DEVELOPMENT REVIEW COMMITTEE (DRC) COMMENT REPORT

PROJECT NAME: 2025 Sunrise

CASE NUMBER: PL-R19056

REQUEST: Site Plan Level III Review: Conditional Use for Waterway Use, Mixed-Use Development with Allocation of 55 Residential Flex Units

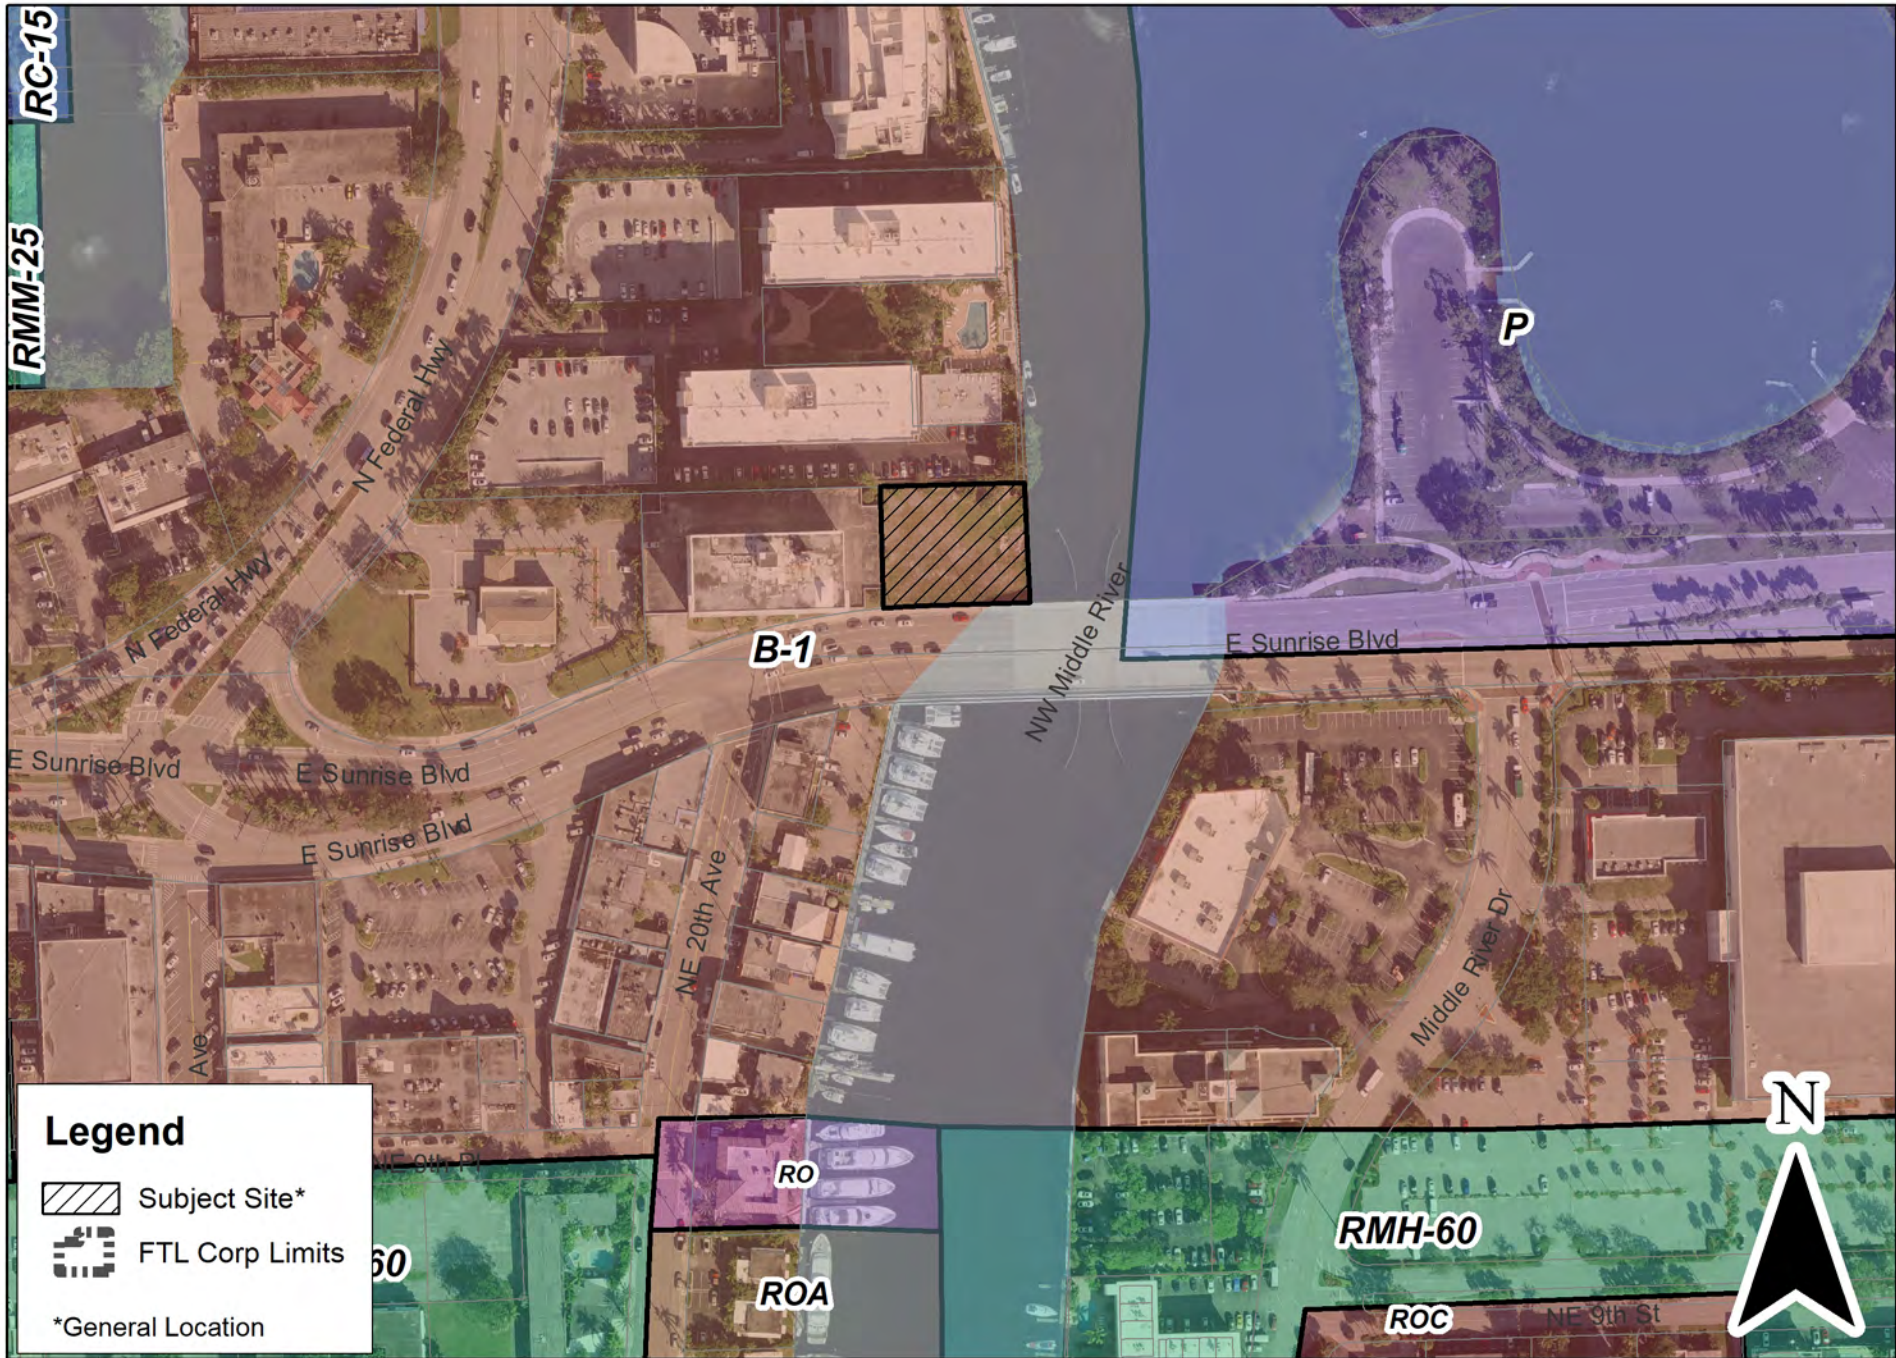
- d. Include the required 1,400 square foot plaza requirement, pursuant to Section 47-18.21.H.3 - Landscape and open space requirements. Plaza requirements are not permitted to overlap with open space requirements. Add plaza square footage requirements to the Site Data Table, Sheet, A-004,
